NORTH SYDNEY COUNCIL

I wish to inform you that a Meeting of the **NORTH SYDNEY LOCAL PLANNING PANEL** will be held in the Supper Room, Council Chambers North Sydney at 2:00pm on Wednesday 4 June 2025.

BUSINESS**LPP01: 47 Devonshire Street, Crows Nest - DA 420/24**

Figure 1: Delete portion of WIR and bathroom as shaded in grey
Obscure Glazing W26

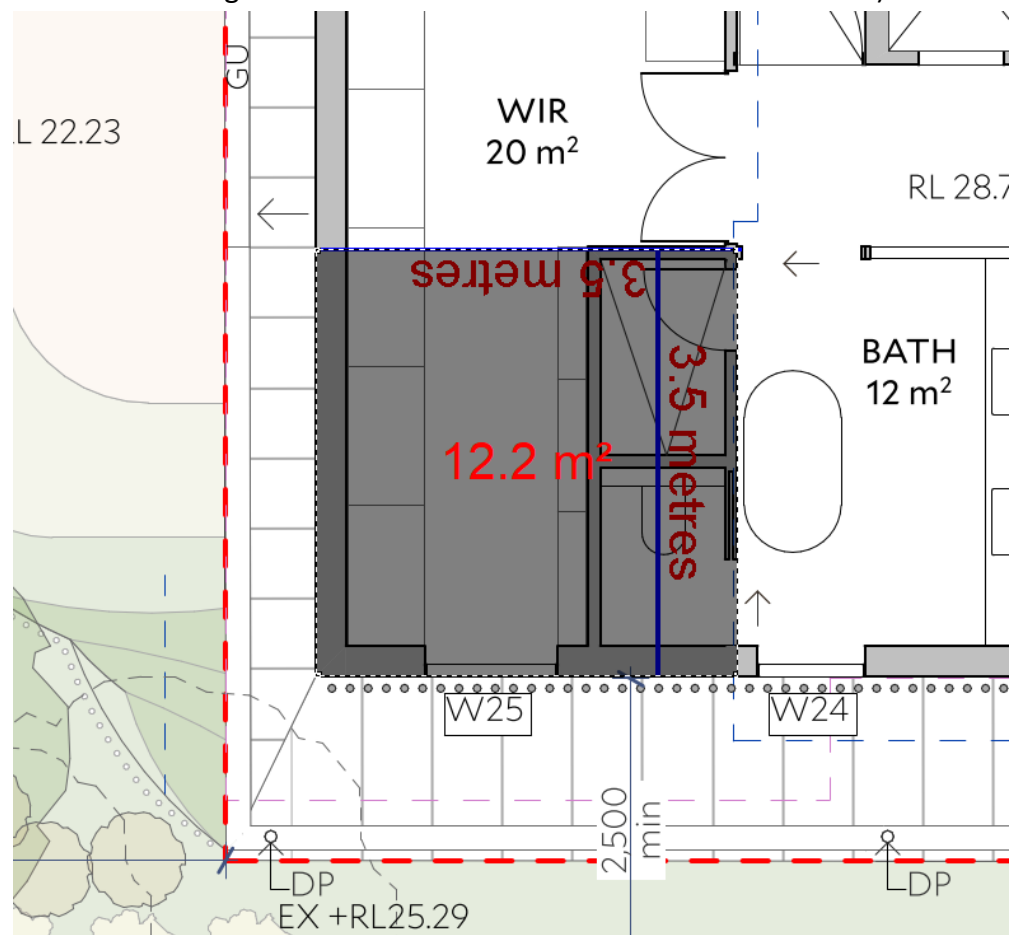
Proposed Master Bed Level WIR Reduced from the south

A5. The setback of the WIR on the master bed level is to be increased by 3.5m along both the southern and western elevations as identified in **Figure 1** below. The grey area in Figure 1 is to be deleted and must not be reconfigured or converted into usable GFA due to the view corridor.

(Reason: To ensure the composition of iconic view of the Sydney Harbour Bridge is protected for 19 King George Street; To ensure view sharing in accordance with *NSLEP 2013* and *NSDCP 2013*)
